Project 86-060-24
December 1990

Response to Comments and Proposed Reclamation Plan Modifications

Church Rock Site
Gallup, New Mexico

United Nuclear Corporation
Gallup, New Mexico

DATE: 11-12-90	FIGURE 2-6	DRAWING NUMBER 86-060-B421
SCALE: AS SHOWN

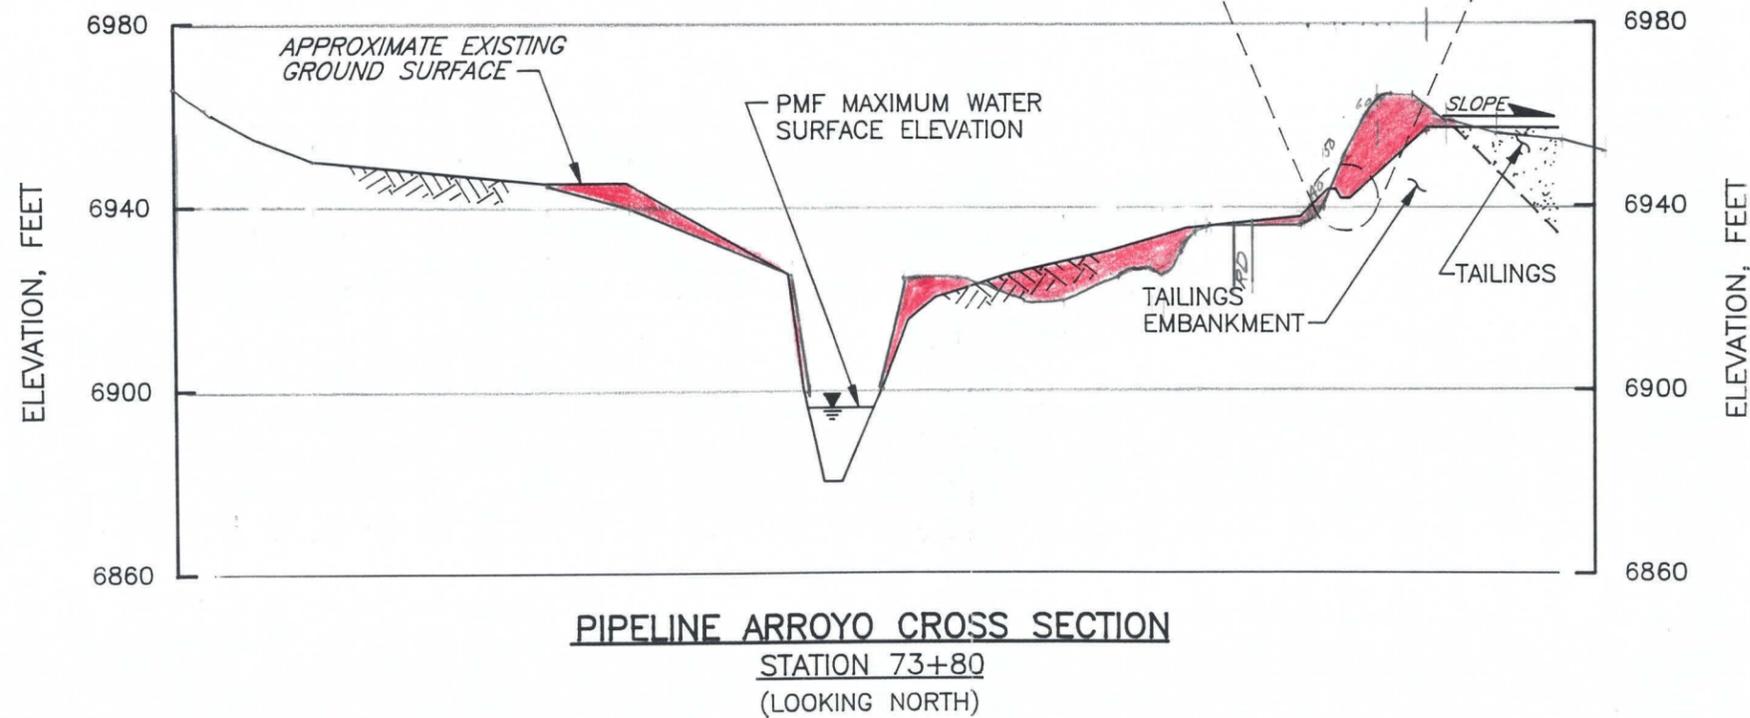
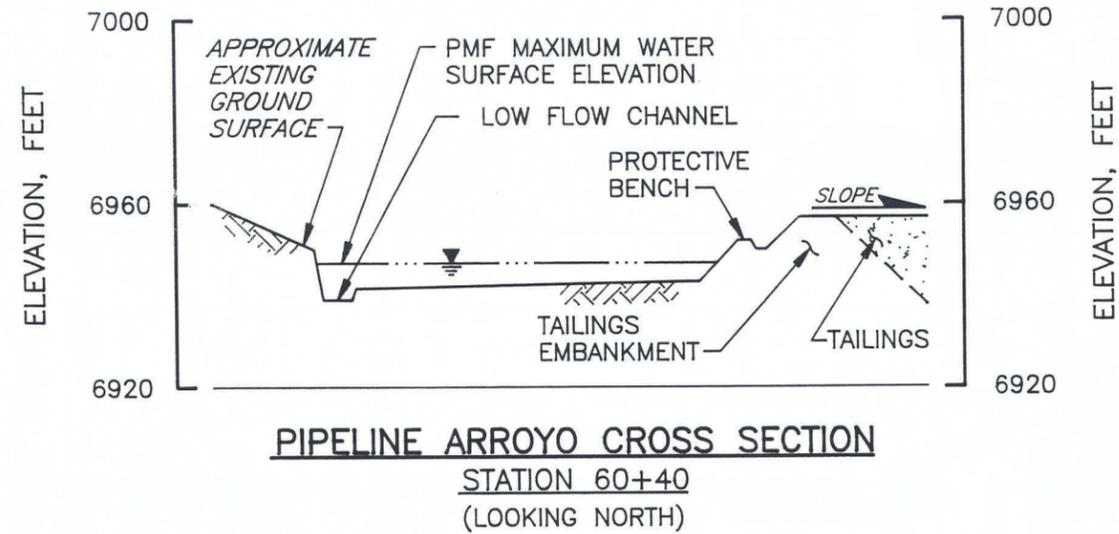
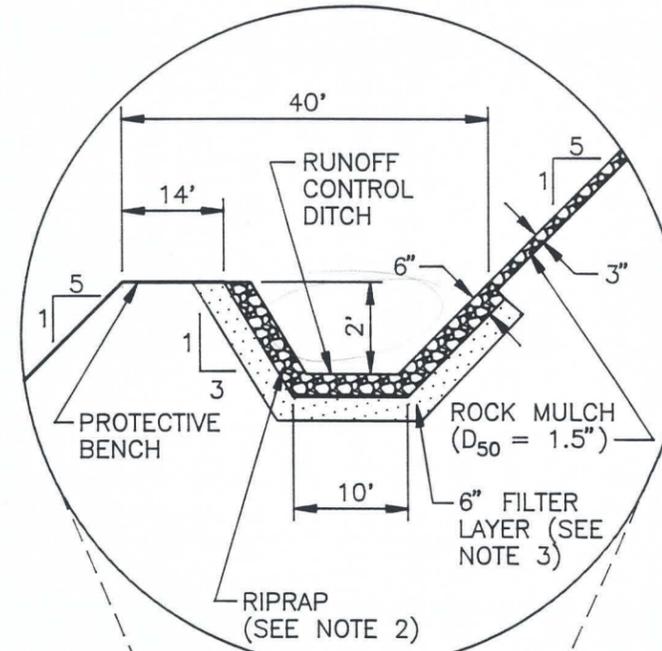
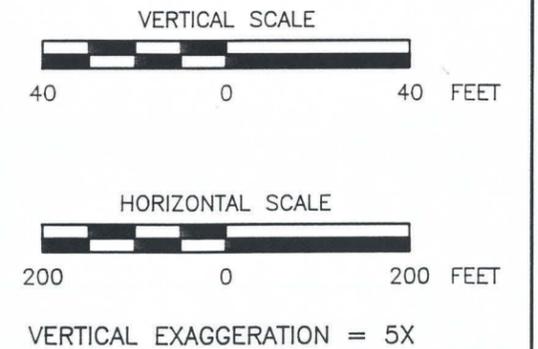
The runoff control ditch, located on the protective bench, would also be located between the embankment toe and the Pipeline Arroyo channel. The top of the protective bench would be 40 feet wide and up to 20 feet higher than the Pipeline Arroyo channel bank. Figure 2-4 shows the profiles of the bench toe, bench top, and embankment top. Figures 2-5 and 2-6 provide several cross sections that illustrate the spatial relationship between these features as well as the Pipeline Arroyo channel. Figure 2-6 provides a detail of the runoff control ditch.

The evaluation indicated that the maximum lateral bank scour to be expected during the passage of the PMF was 4.9 feet. As shown on Figure 2-6 the runoff control ditch would be located 14 feet from the protective bench edge, and the tailings embankment toe is 40 feet from the protective bench. Thus, the PMF would not contact either the runoff control ditch or the tailings embankment toe.

Figures 2-5 and 2-6 provide several cross sections across Pipeline Arroyo to the reclaimed tailings embankment top. These cross sections also illustrate the spatial relationships between the channel, bench, and embankment.

86-060-B428	DATE: 11-14-90 SCALE: AS SHOWN	FIGURE 2-7	DRAWING NUMBER 86-060-B430
-------------	-----------------------------------	------------	-------------------------------

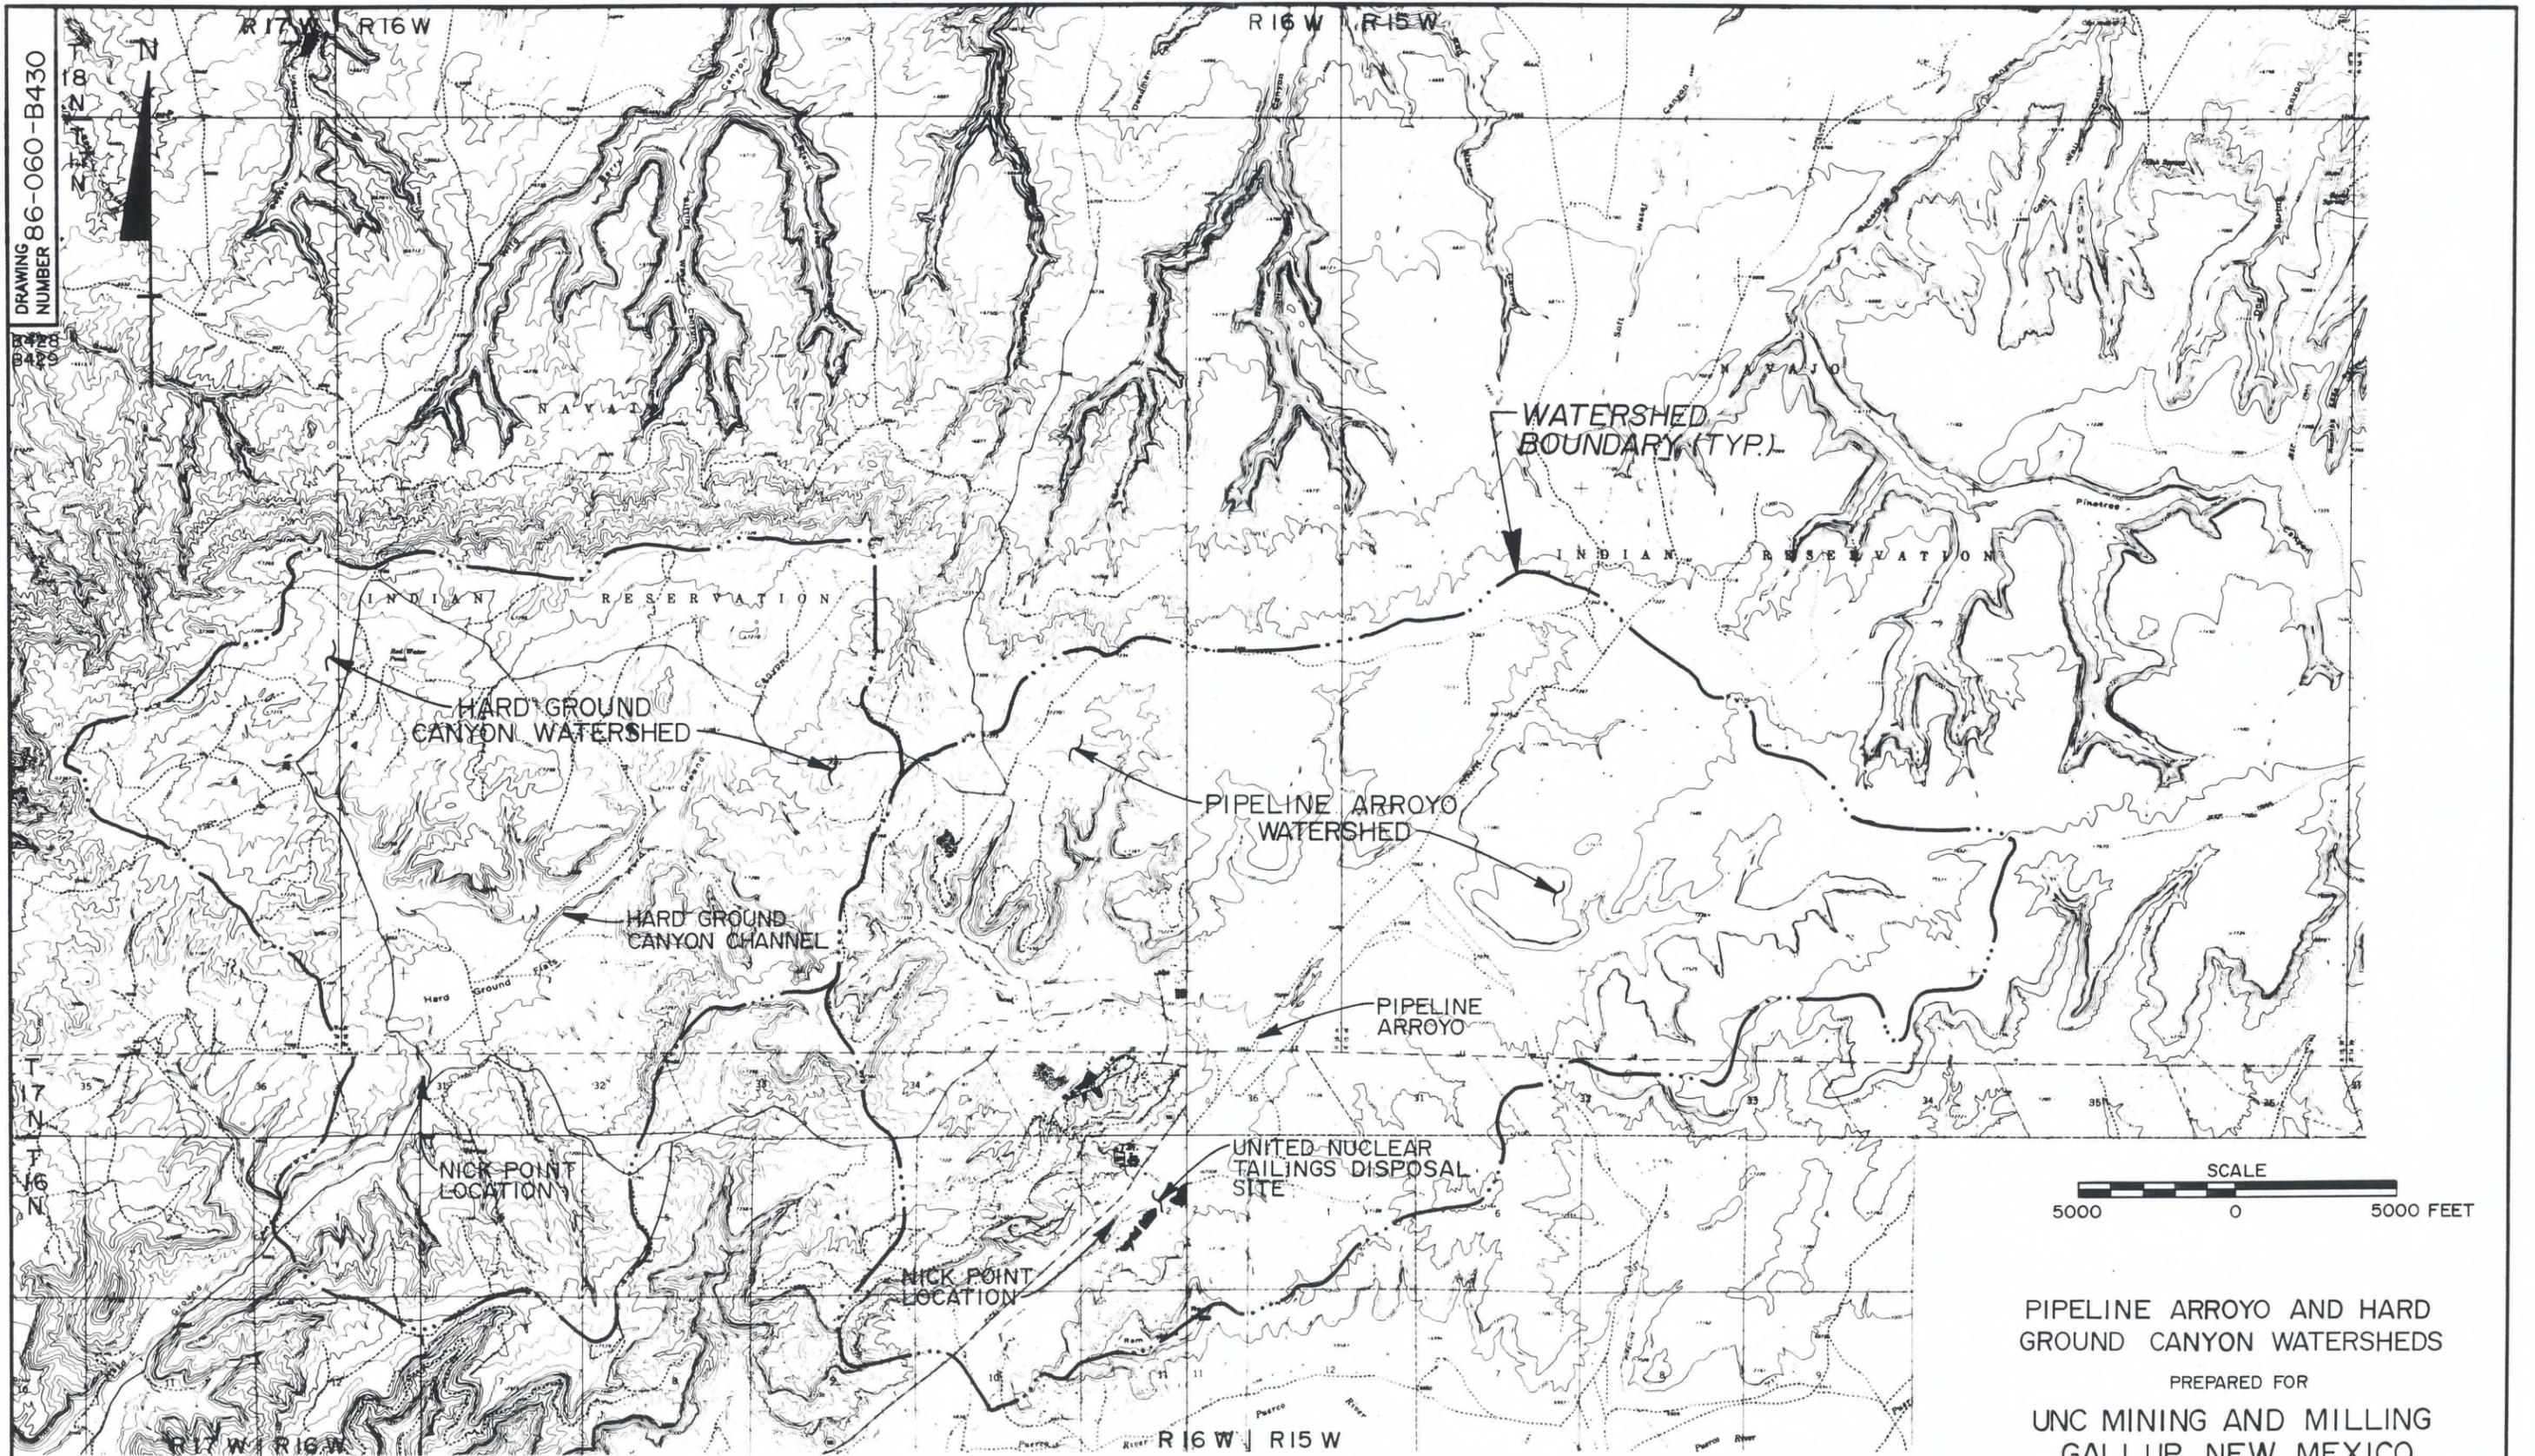
Figure 2-7 shows the channel reaches and watersheds that were characterized in the watershed known as Hard Ground Canyon, which is about 5 miles north-west of Pipeline Arroyo. The two watersheds are similar in size, soil, and vegetation characteristics. The channels that drain these watersheds are also similar in that their lower reaches are deeply incised, probably by headcutting that has migrated from downstream areas. The headcuts have been terminated by sandstone outcrops (nickpoints) that have resulted in the formation of large alluvial-fill valleys upgradient of the nickpoint. The channels upgradient of the nickpoint have shallow slopes.

DATE:	11-15-90	FIGURE 2-8	DRAWING NUMBER 86-060-E419
SCALE:	AS SHOWN

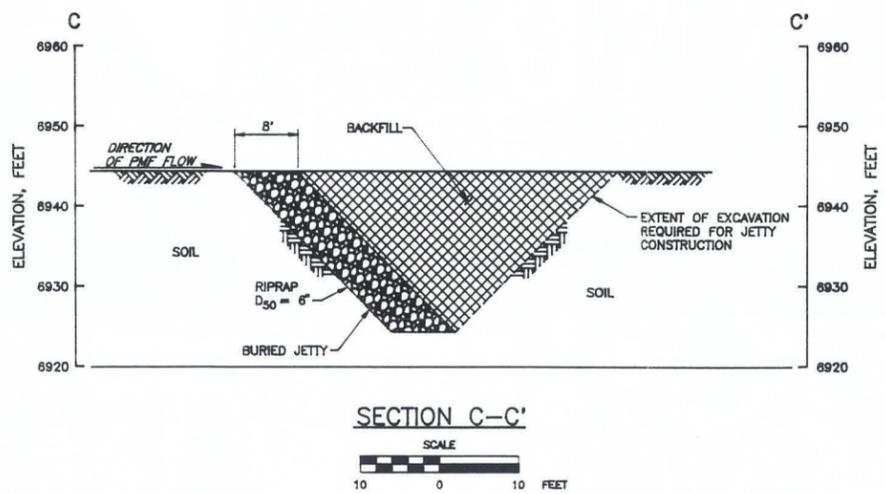
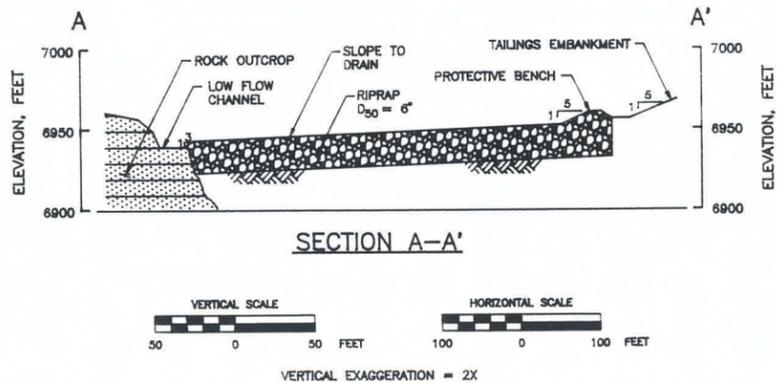
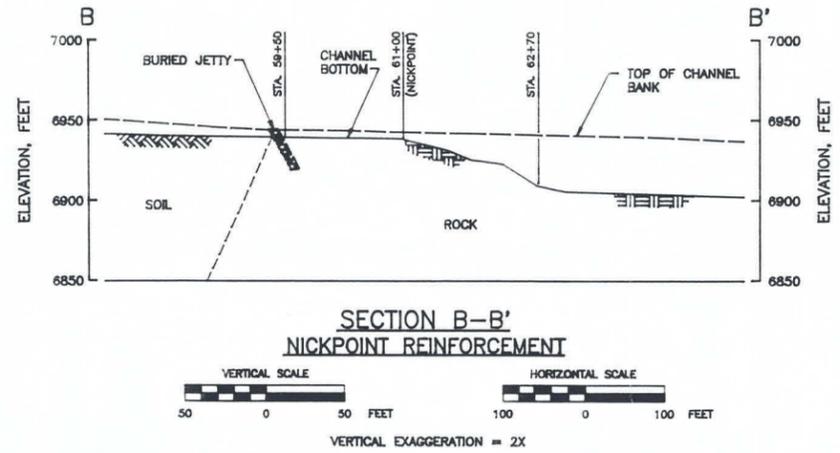
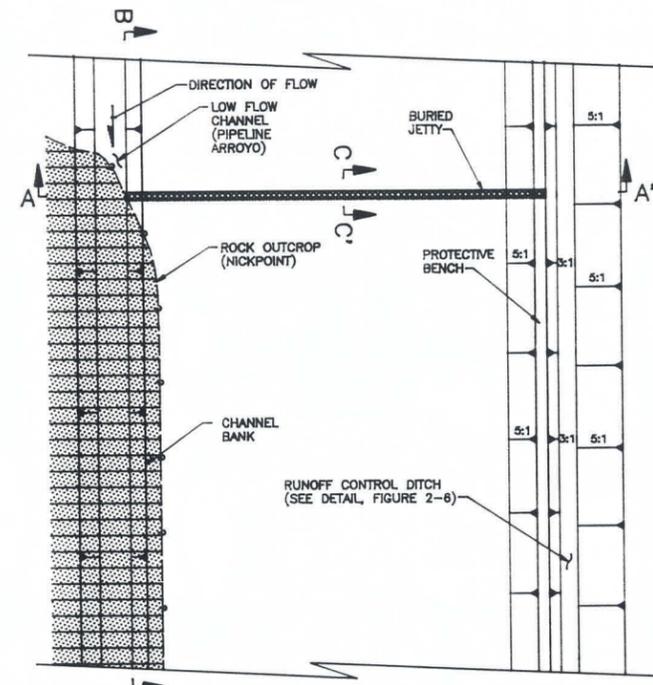
Figure 2-2 shows the location of the proposed jetty, while Figure 2-8 provides the jetty details. The jetty would be keyed into the nickpoint at its furthest extent to maximize the flow capacity within the nickpoint. The exact configuration of the eastern edge of the nickpoint will be determined in the field at the time of construction. For the present design, the low-flow channel was considered to be 30 feet wide and located at the west terminus of the jetty. The low-flow channel may be wider, depending on the nickpoint configuration.

As shown on Section B-B' of Figure 2-8, any potential headcuts would have to start at least 150 feet downstream from the proposed jetty at the beginning of Reach 3. The low-flow channel remains stable for this distance at a constant low slope on the rock of the nickpoint. Thus, the propensity for creating headcuts would not exist in the first 150 feet below the jetty because any flows in the overbank area would be traveling parallel to the channel banks.

Headcuts that could affect the toe of the proposed jetty would have to start at least 308 feet downstream from the proposed jetty. As shown on Section C-C' of Figure 2-8, the toe of the jetty would extend downward to an elevation of 6,923 feet at Station 59+70. Assuming a headcut channel slope of 0.01 ft/ft, a potential headcut would have to form at or below Station 62+78 where the Pipeline Arroyo channel bottom is at elevation 6,920 feet to be able to be below elevation 6,923 feet at the toe of the proposed jetty. The distance this potential headcut would have to migrate is about 308 feet from Station 62+78 to Station 59+70.
